Form 3160-5
(June 2019)UNITED STATES
DEPARTMENT OF THE INTERIOR
BUREAU OF LAND MANAGEMENTFORM APPROVED
OMB No. 1004-0137
Expires: October 31, 2021**SUNDRY NOTICES AND REPORTS ON WELLS**
Do not use this form for proposals to drill or to re-enter an abandoned well. Use Form 3160-3 (APD) for such proposals.

8. Well Name and No.
MIDNIGHT HOUR 11 FED COM/763H

Midnight Hour 11 Fed Com 763H

EOG respectfully requests an amendment to our approved APD for this well to reflect the following changes:

Plan #0.3

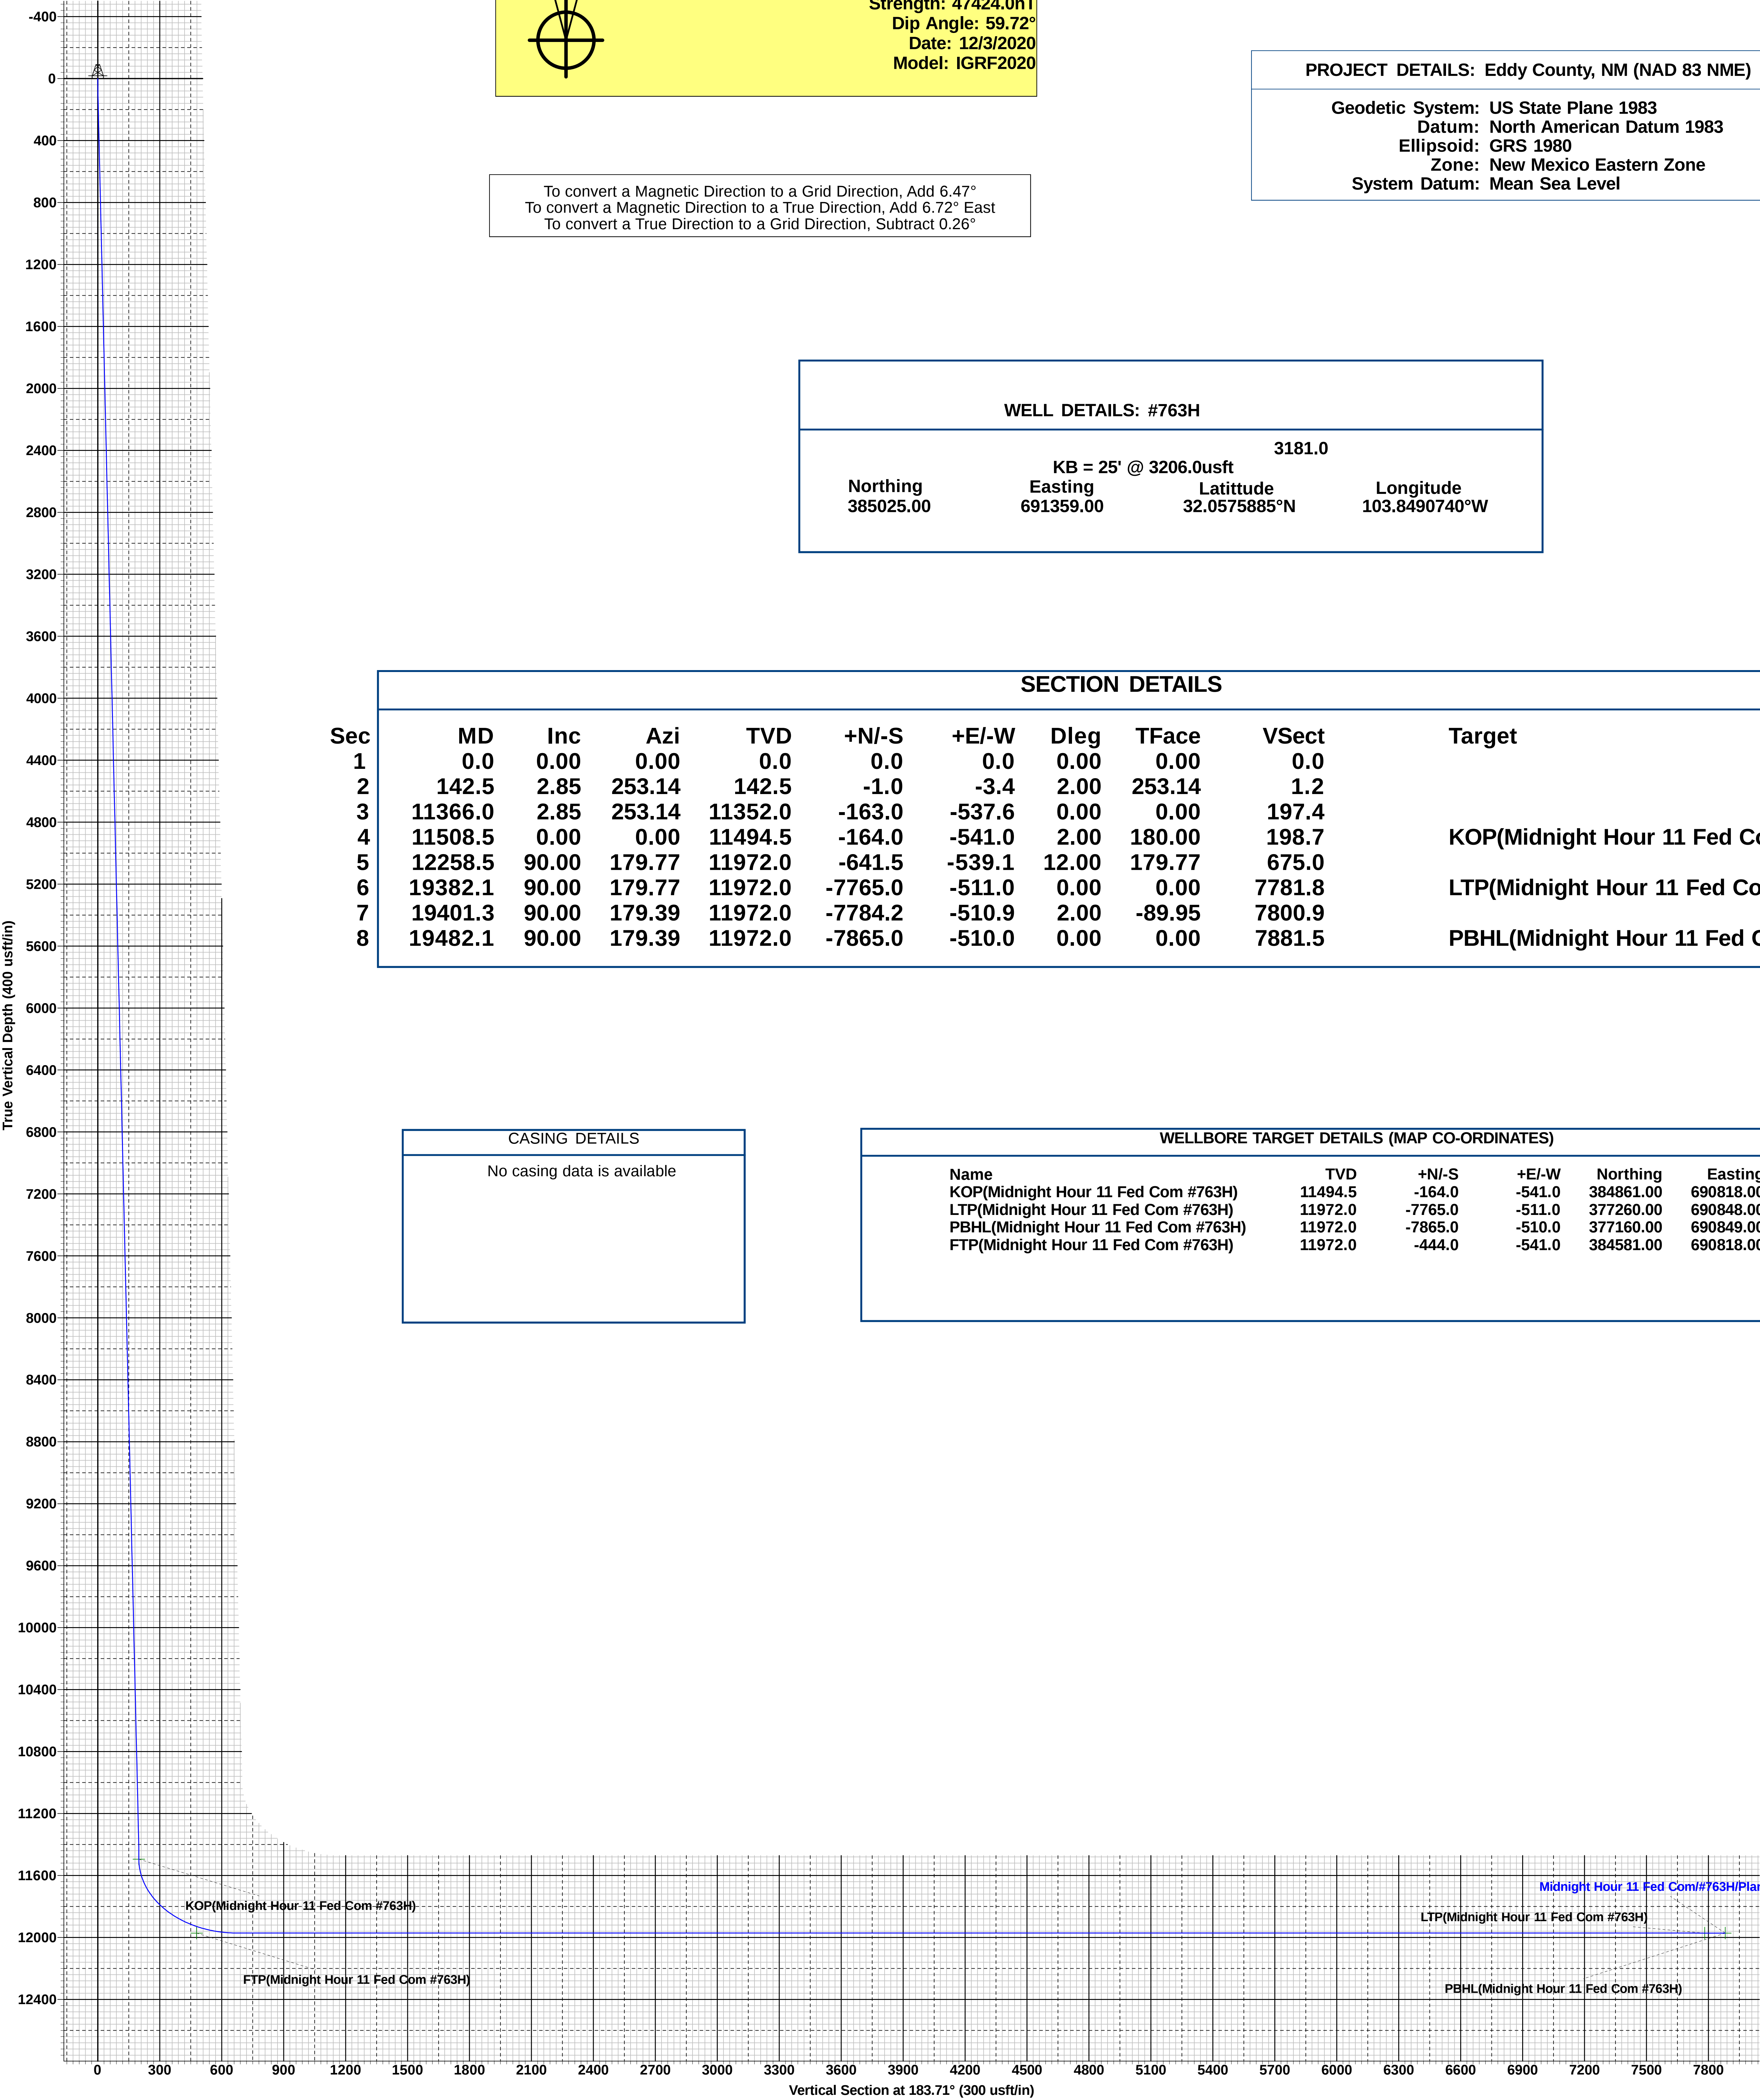
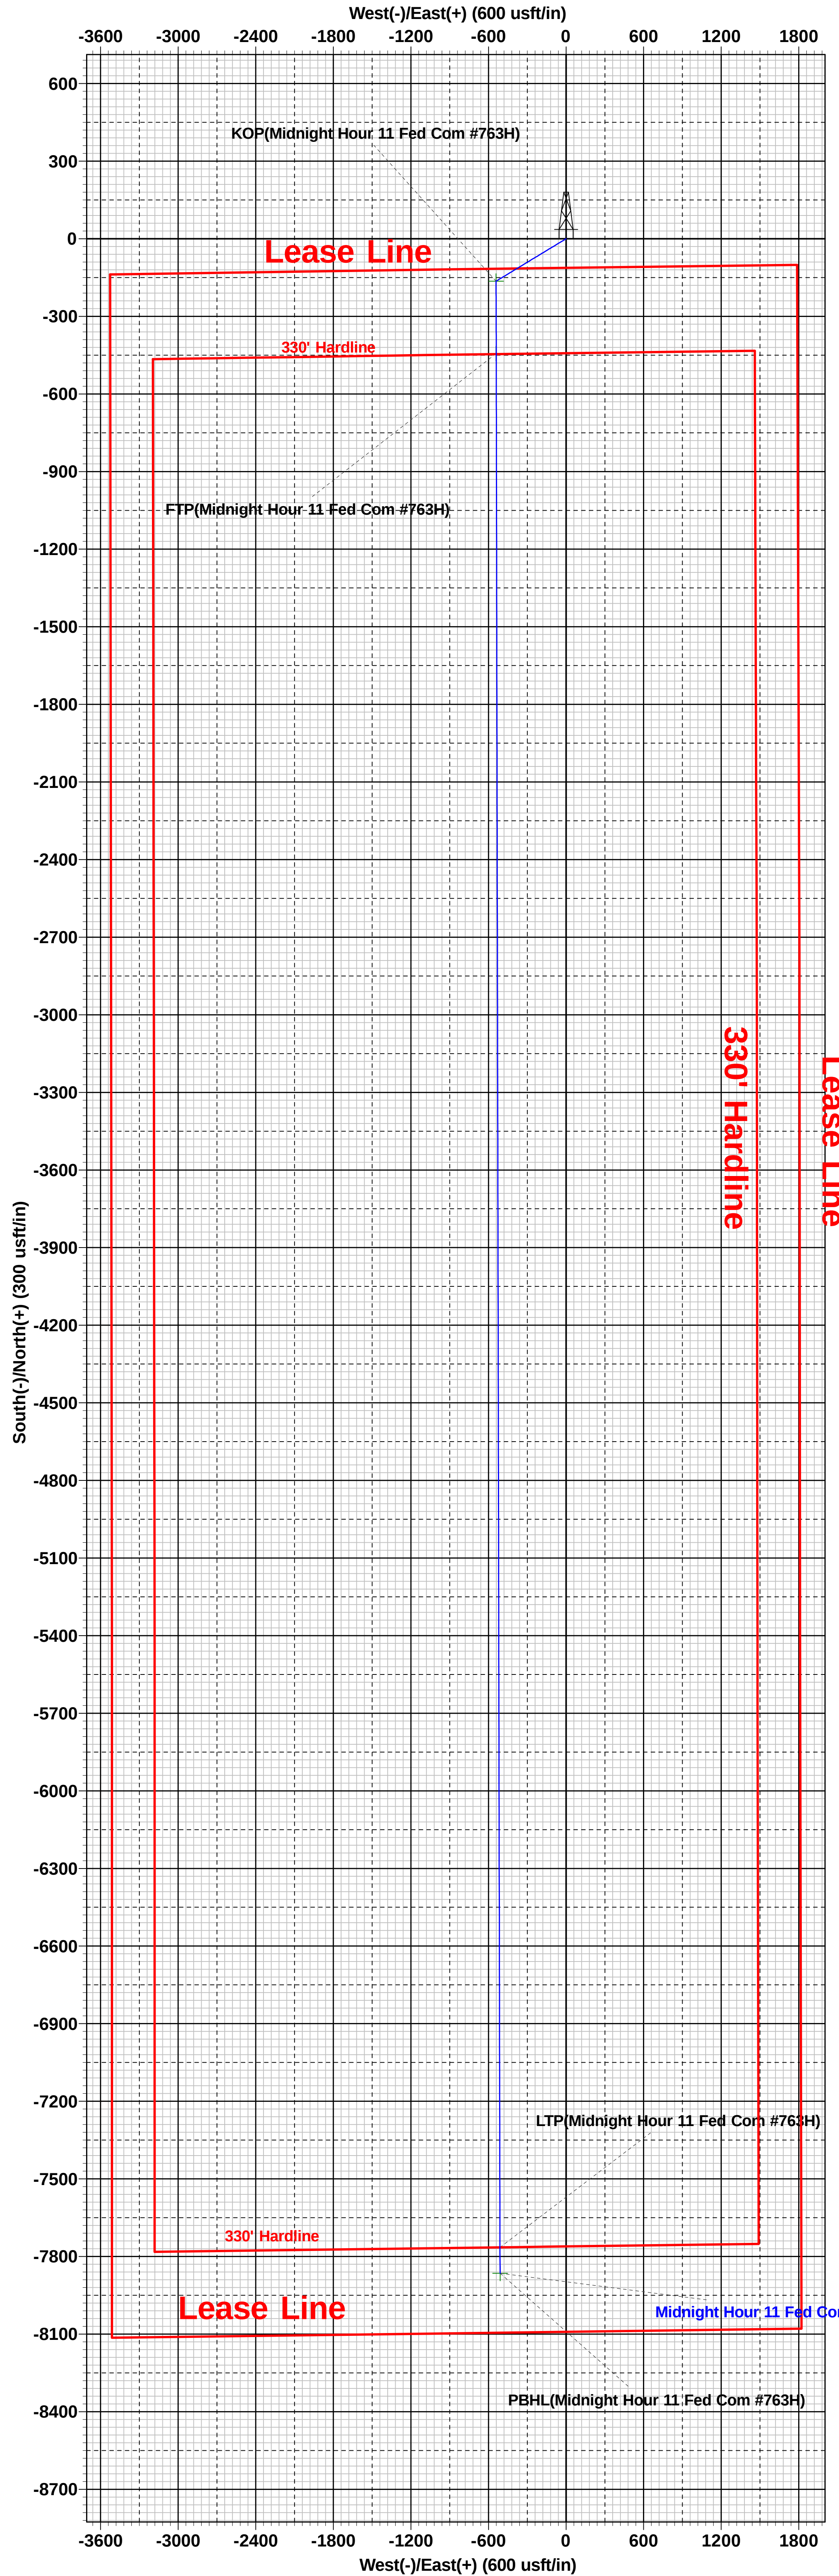
Change SHL from T-26-S, R-30-E, Sec 11, 2296' FNL, 1425' FEL, Eddy Co., NM, to T-26-S, R-30-E, Sec 11, 2555' FNL, 1786' FEL, Eddy Co., N.M.

Change BHL from T-26-S, R-30-E, Sec 14, 230' FSL, 1980' FEL, Eddy Co., NM, to T-26-S, R-30-E, Sec 14, 230' FSL, 2330' FEL, Eddy Co., N.M.
